## STATE OF WASHINGTON DEPARTMENT OF ECOLOGY

Re: Opinion on Proposed Cleanup of the following Site:

• Site Name: Gig Harbor Transmission

The Washington State Department of Ecology (Ecology) received your request for an opinion on your proposed independent cleanup of the Gig Harbor Transmission facility (Site). This letter provides our opinion. We are providing this opinion under the authority of the Model Toxics Control Act (MTCA), Chapter 70.105D RCW.

### **Confirmation Soil Sample Location Map**

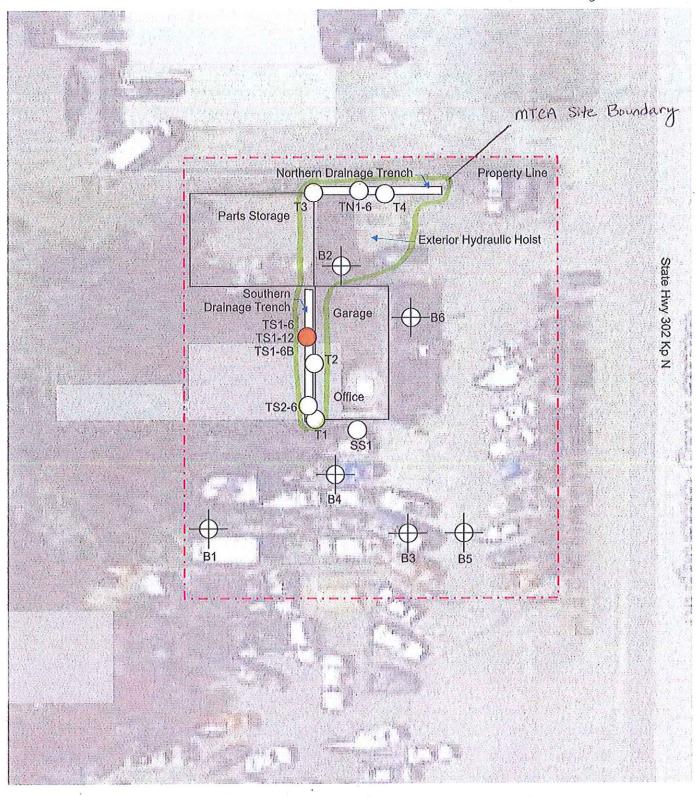
In 2017, concentrations of Site COCs in soil sampled from the concrete lined west trench<sup>1</sup> exceeded the MTCA Method A cleanup level. Ecology identifies the MTCA "Site" as an area encompassing those areas which have had concentrations of Site COCs in excess of the cleanup levels and where removal of potentially contaminated soils has occurred. In the MTCA Site, Ecology includes west trench and the north trench, and the area in the vicinity of boring B2. Ecology added the approximate MTCA Site boundary to figure 5 in **Enclosure A**. New data may alter the boundaries of the MTCA Site.

Based on the 2017 Phase I ESA findings, ECI sampled soil from the same trenches as completed in 2009. Concentrations of TPH-O, cPAHs, and lead exceeded the MTCA Method A cleanup levels in soil sampled from west trench. Cadmium was not sampled in soil collected from the western trench in 2017, though this contaminant exceeded the MTCA Method A cleanup level in soil sampled in 2009. The west trench is enclosed in concrete (see Figure 4). Petroleum contaminated soils (PCS) in both the west trench and the north trench were removed and disposed of off-Site by PRS Group, Inc.

- A. In order to verify if the results of the grab groundwater sample at B2 are representative of Site groundwater quality, and to determine whether or not groundwater has been contaminated by the release identified in January 2017, Ecology requests installation of one monitoring well at boring location B2.
